Determination 2024/020

Compliance of a CCTV system relating to awareness of the outside

2 Bliss Court, Papakura, Auckland

Figure 1: proposed firewall in front of units on Lots 3 and 4

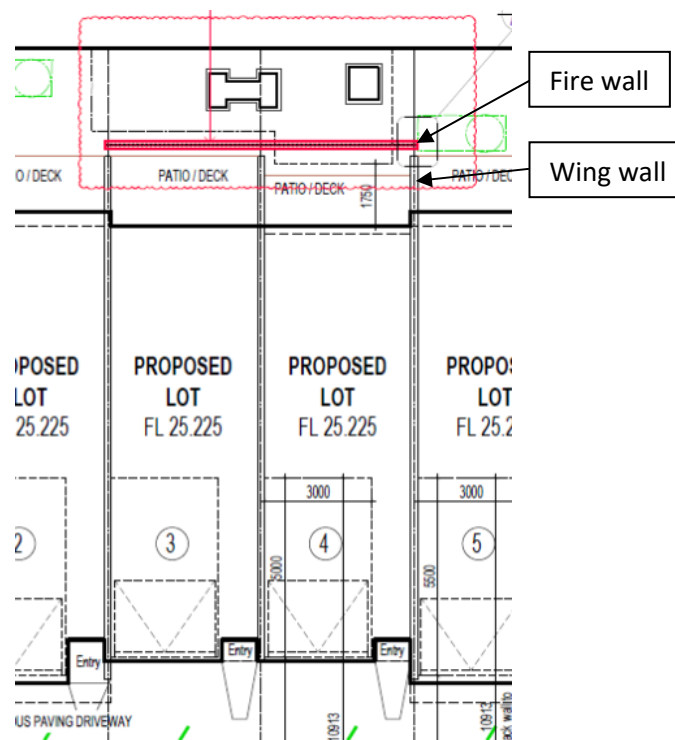
- 3.5. The living room on the ground floor of each unit has an opening to the outside, being the sliding door that provides access to the patio. However, the outdoor area on the ground floor on Lots 3 and 4 is effectively enclosed by the wing walls, solid block fire wall and balcony above. The fire wall is attached to but set off from the wing walls. Based on the drawings, I am of the view the limited separation between the wing walls and fire wall is not sufficient to provide awareness of the outside from the habitable space in the units.

- 3.6. It is the building work that must achieve compliance. The building work as proposed does not comply because the opening in the building, being the doors that open onto the patio do not give the occupant of the habitable space awareness of the outside. The use of the CCTV is not an “opening” in the building, and its use is subject to operation by the occupant of the building.

- 3.7. In conclusion, the proposal to install CCTV does not meet the performance criteria in clause G7.3.2, and with regard to the proposed fire wall the units on Lots 3 and 4 do not comply.

Figure 2: Elevation showing the proposed fire wall attached to wing walls

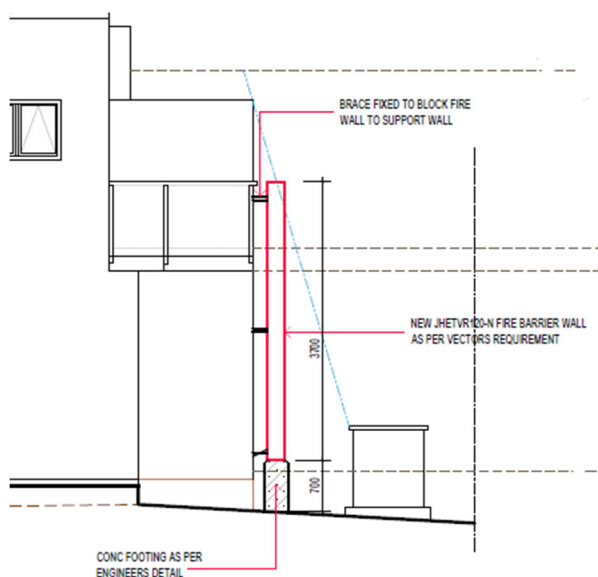
- 2.4. The fire wall is 4.4m high and is fixed to the wing walls. I have not been provided the dimension between the wing walls and the fire wall.

Please demonstrate compliance with the NZBC clauses...G7.3.2 is achieved to Units 3 & 4 ground floor lounge/ dining...awareness of outside.... considering the construction of the fire barrier.

What you are proposing is an alternative solution which we do not know it complies with the building code. Thus, we are asking you to provide information...[regarding how compliance is achieved with G7.3.2 of the Building Code]”

- 4.1. In accordance with section 188 of the Building Act 2004, I determine units on Lots 3 and 4, in relation to the fire wall and with CCTV cameras as proposed, do not comply with the Building Code clause G7.3.2 for awareness of the outside.
